Product Change Notification (PCN)

PCN #: 8F-2026 Rev 1.1 *Date: October 12th, 2026*

Revision 1.1 summary: Issued October 12th, 2026. This revision adds guidance for customers and distributors holding units built to the previous revision (see Recommended Customer Action). The technical change described in this notice is unchanged.

6.1 Designator R41

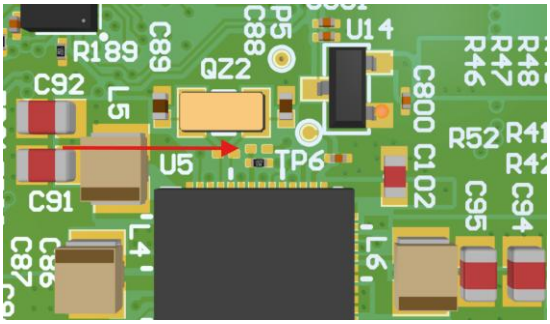
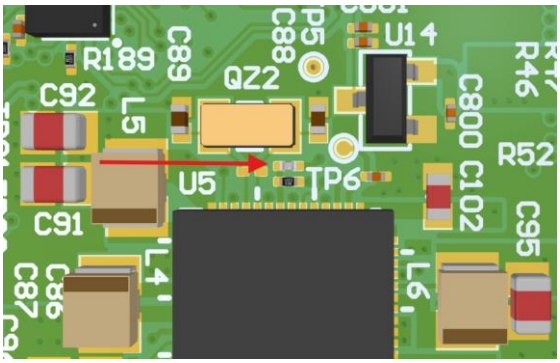
1) Replace the existing BAT54C with a lower-forward-voltage Schottky diode. SDM40E20LC-7 provides lower forward-voltage drop compared with the existing BAT54C, improving the voltage available on the downstream NVCC_BBSM_1V8 rail.

1) The board shows reset/startup reliability issues below -10°C. Investigation indicates that the voltage drop across the existing BAT54C diode reduces the effective NVCC_BBSM_1V8 voltage. This can reduce the high-level margin for PMIC_RST_B.

There is no change to form, fit or function. Units built to the previous revision (BAT54C fitted, R41 unpopulated) and operated in industrial temperature applications may not start reliably at low temperatures. Units built to the new revision are not affected. Please see Recommended Customer Action below.

Industrial temperature variants are identified by the "_i" suffix on the Ezurio part number. The state of designator R41, shown below, identifies the revision.

- Previous REV is unpopulated

- New REV is populated
